ADDENDUM NO. 2

Rochester City School District

Dr. Walter Cooper, School #10

February 28th, 2018

4 ENLARGEMENT AREA - B
 Scale: 1" = 10'

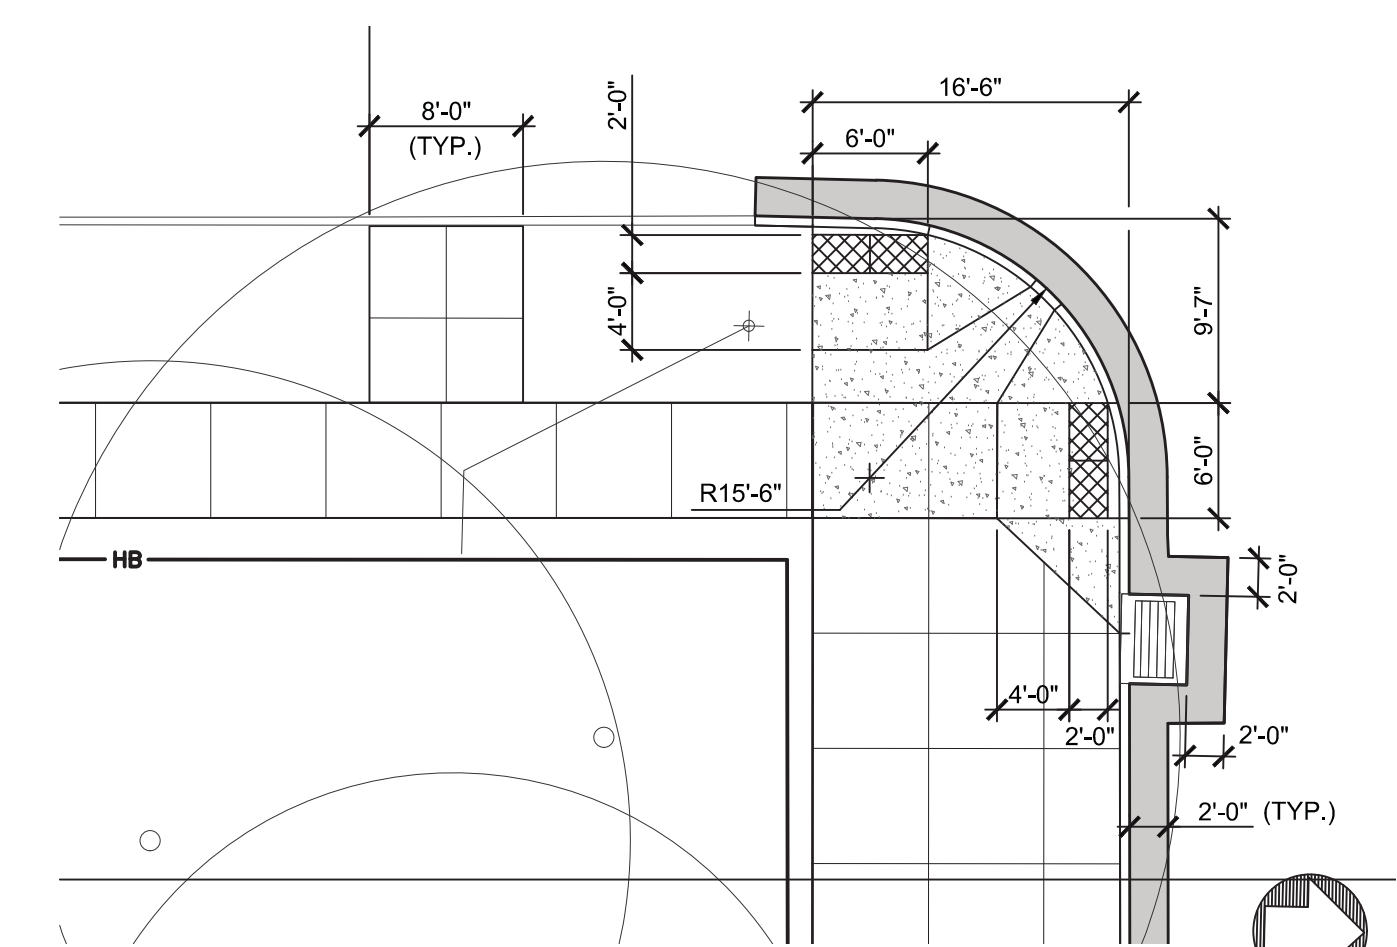
Item AD2-13 **REPLACE** drawing in its entirety with attached “C1102 – SITE LAYOUT PLAN.” Remove pavement and curb restoration where existing utilities will be abandoned in the ROW.

UTILITY PLAN

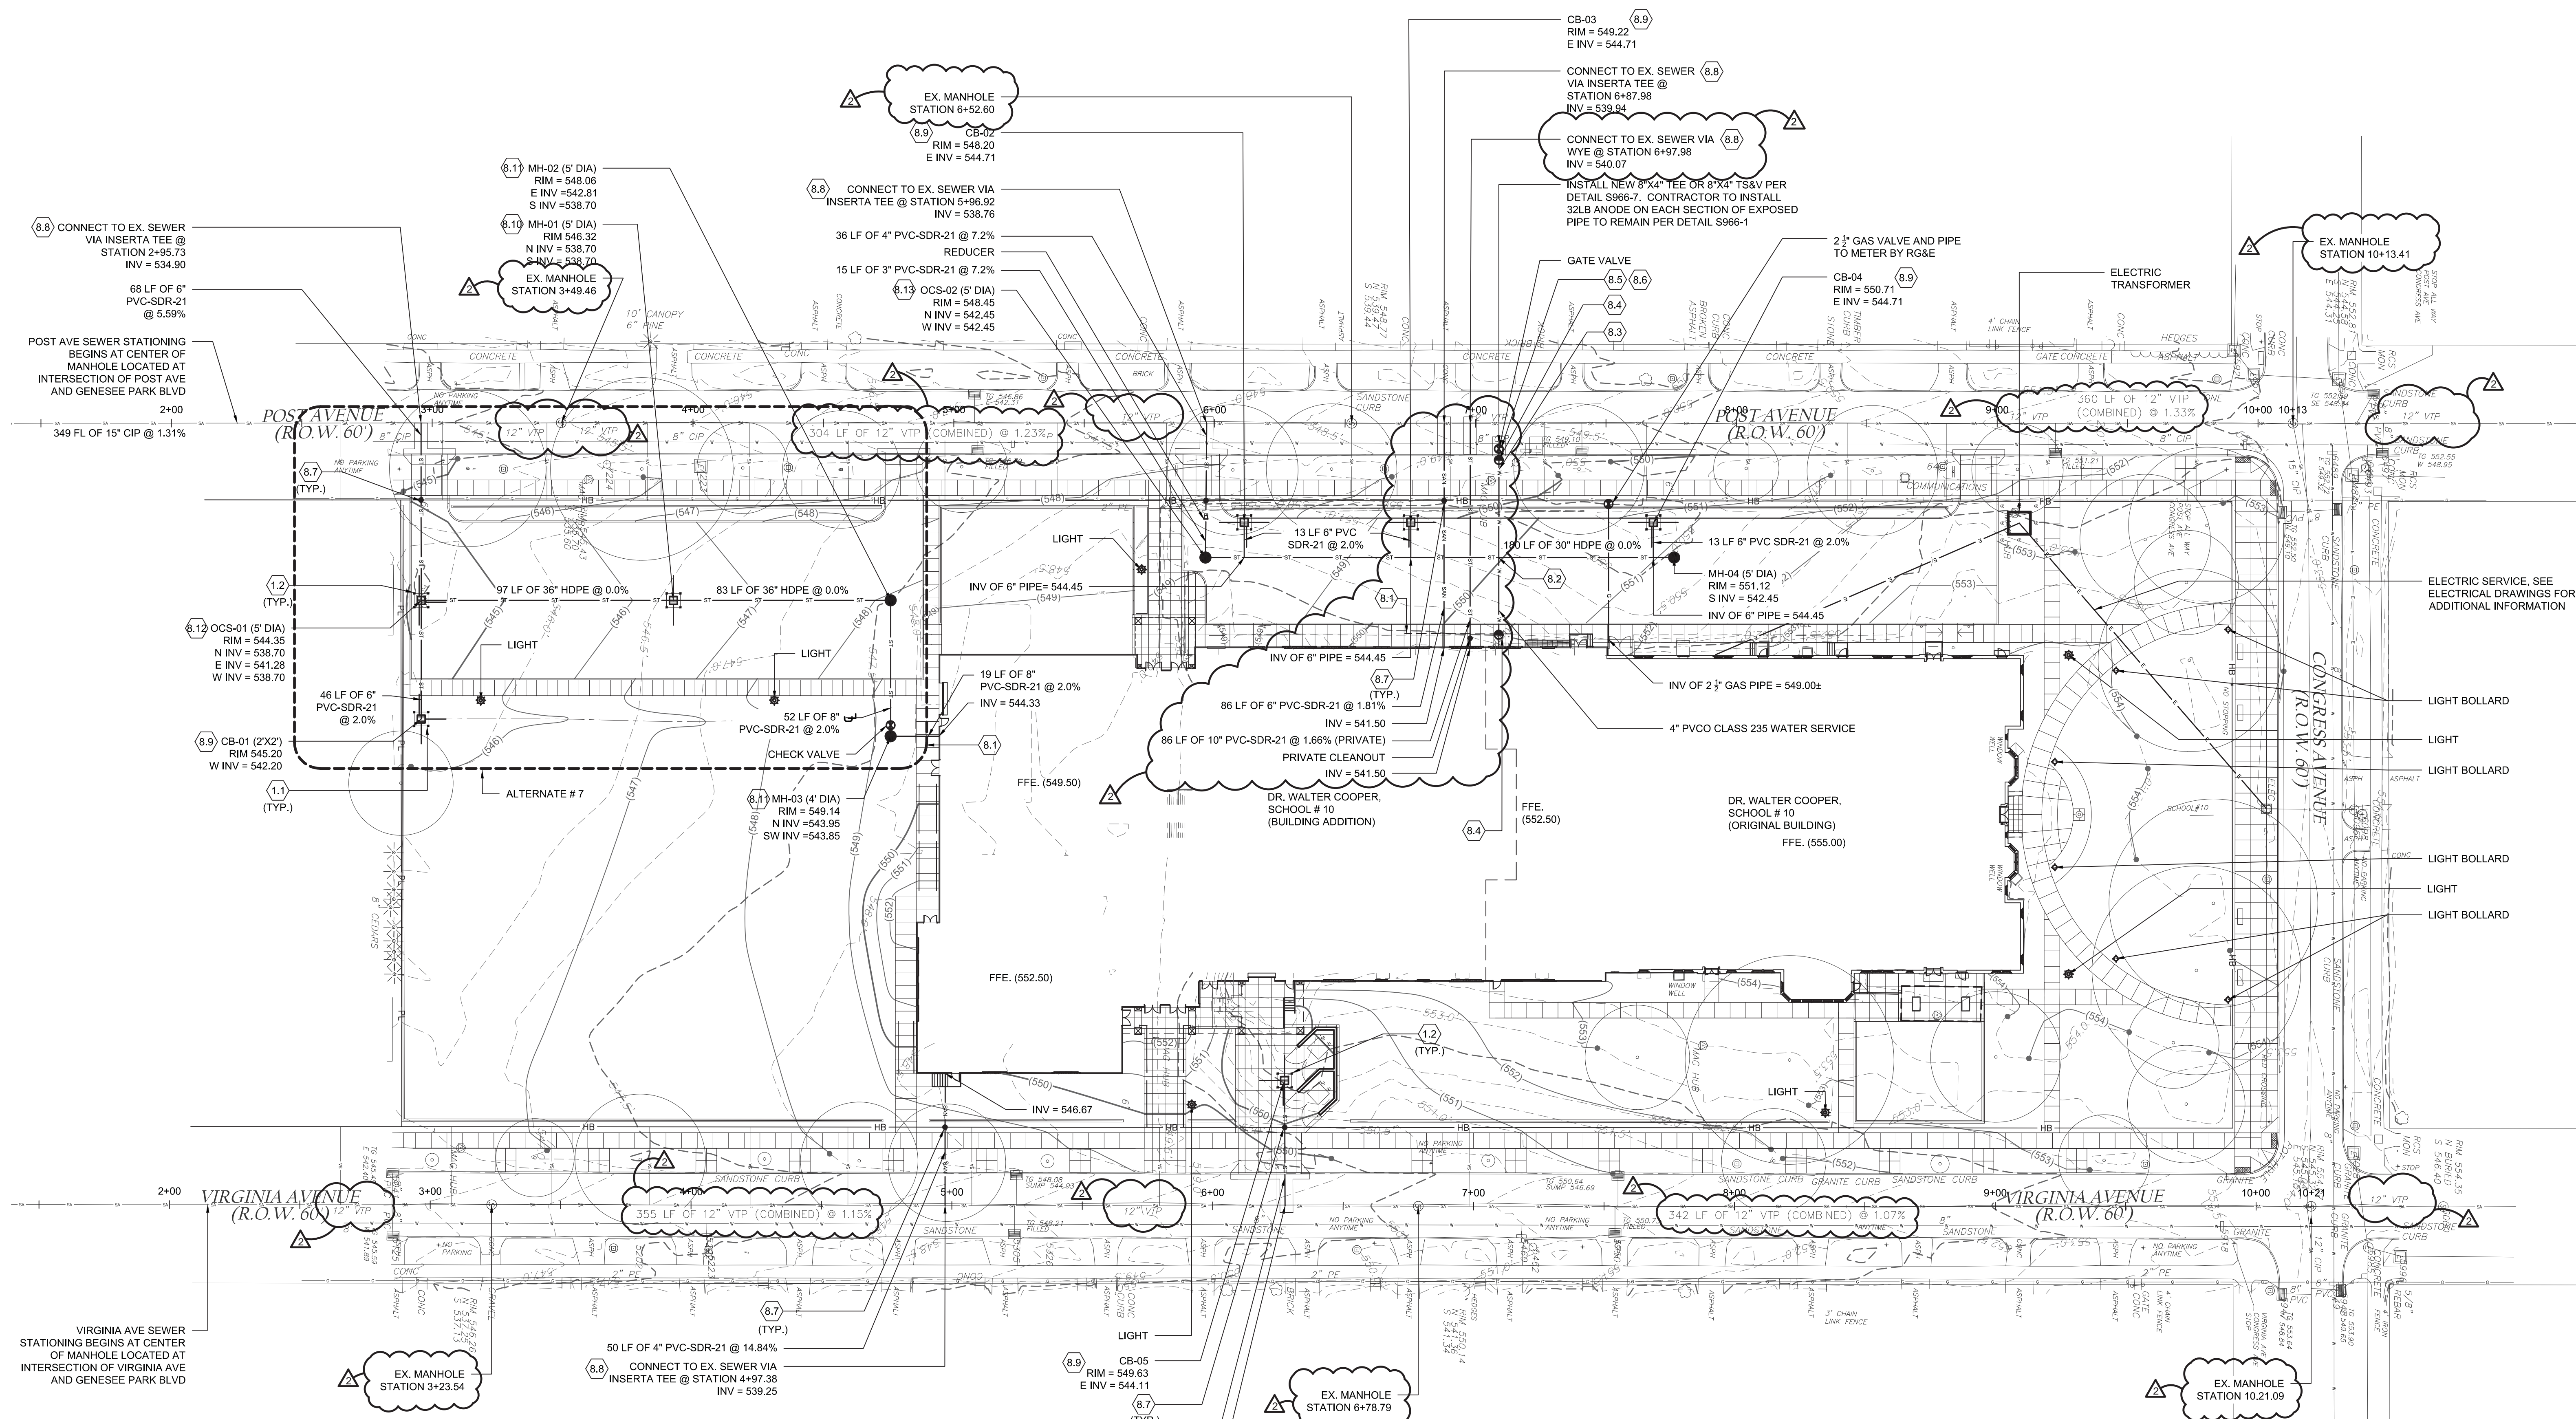
Item AD2-14 **REPLACE** drawing in its entirety with attached “C1301 – UTILITY PLAN.” Various edits per Monroe County Pure Waters review.
